**FINAL
ENVIRONMENTAL IMPACT REPORT
Volume 1: Response to Comments**

**Mount Etna Community Plan Amendment and Rezone Project
SCH No. 2018091016**

**County of San Diego
Department of General Services
5560 Overland Avenue, Suite 410
San Diego, CA 92123
Contact: Marc Cass, Project Manager**

**Environmental Science Associates (ESA)
550 West C Street, Suite 750
San Diego, CA 92101**

Figure 2.4-1
Traffic Study Area

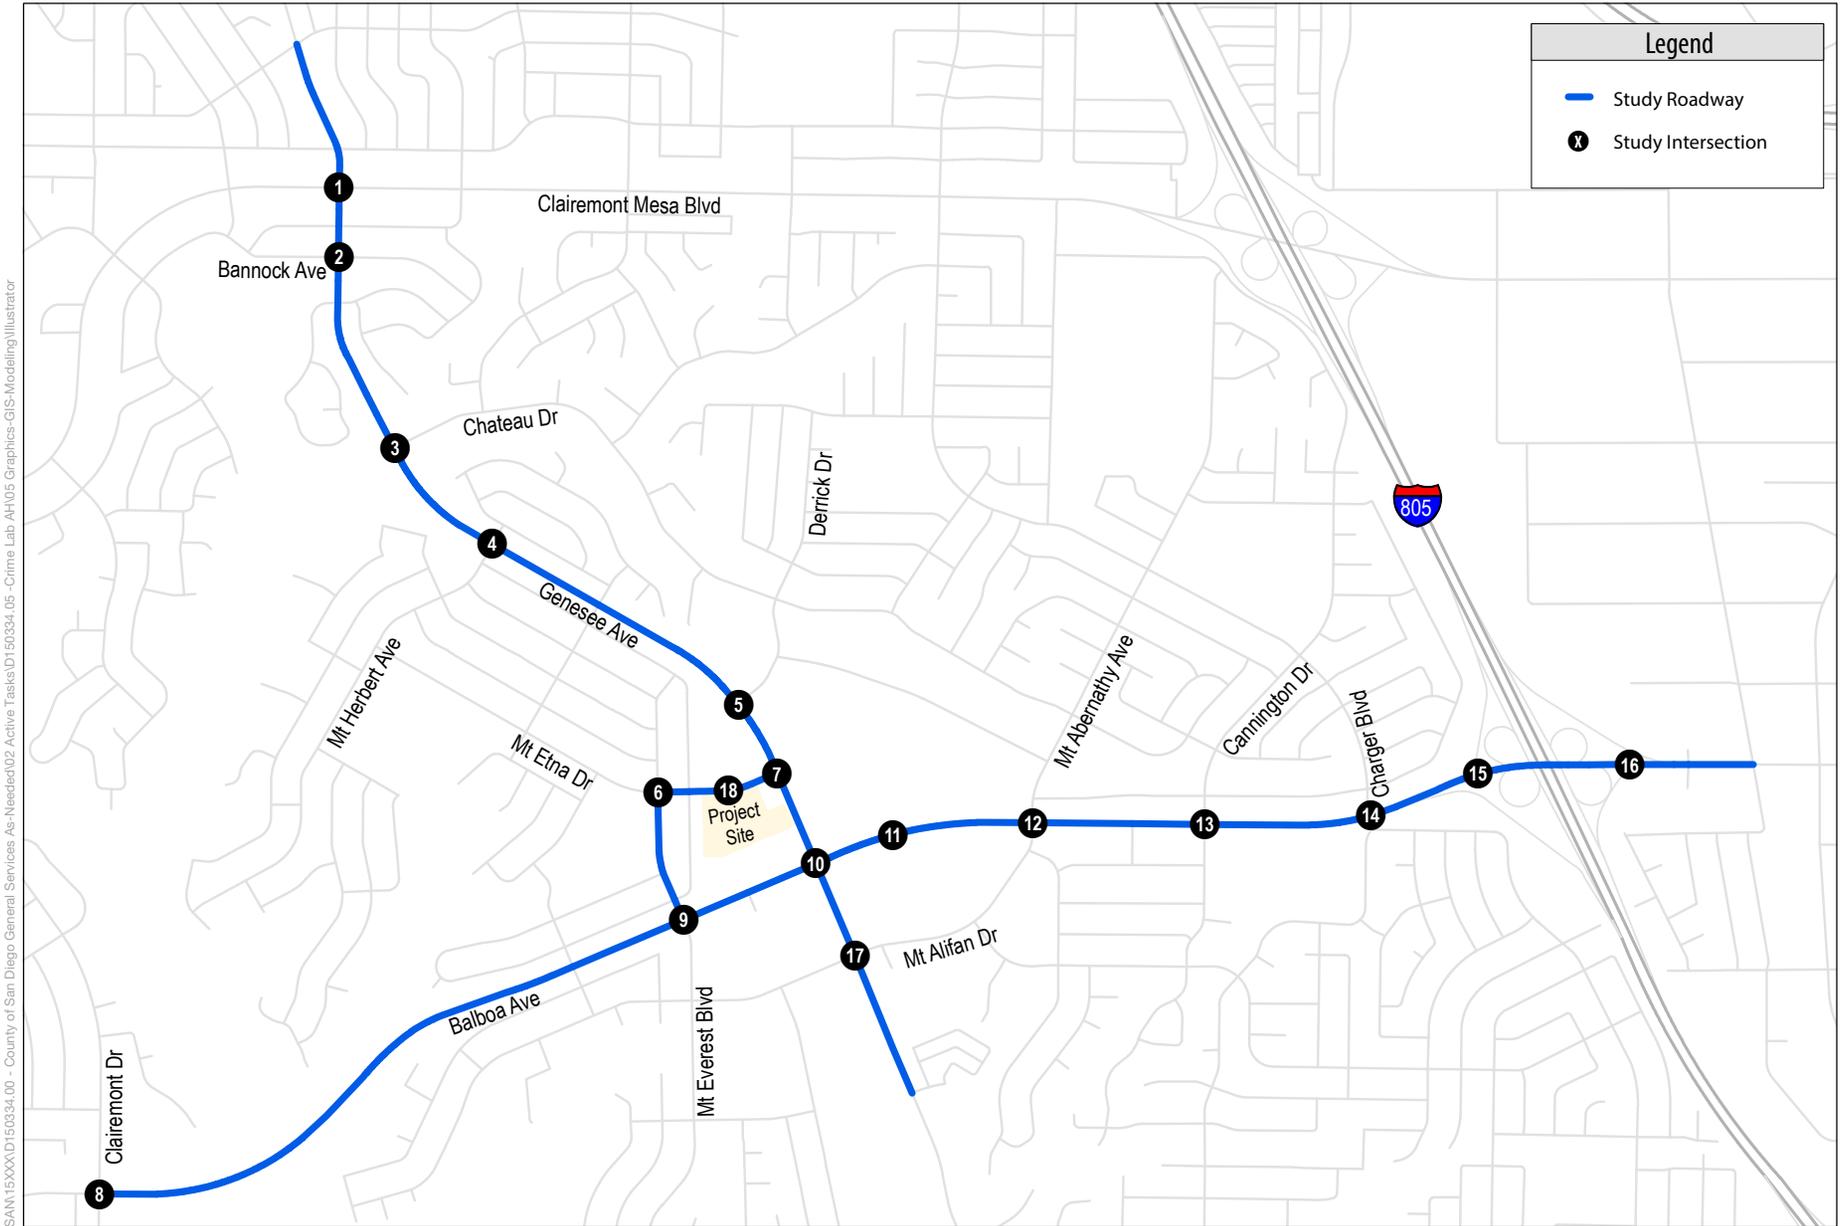
- Page 10 of the Transportation Impact Study section 2.4 references the methodology for the calculation of demand per hour per lane. Max, ramp processing rate is 900 VEH/Hour/Lane. What happens when the project trips are added?

- A1-7 This comment questions what would happen when project trips are added to the ramp processing rate. The TIS analyzes ramp meter operations with the project traffic. The analysis results are included in Tables 2.4-5, 2.4-10, and 2.4-13. The proposed project is not expected to significantly impact the on-ramp operations with the additional project traffic.
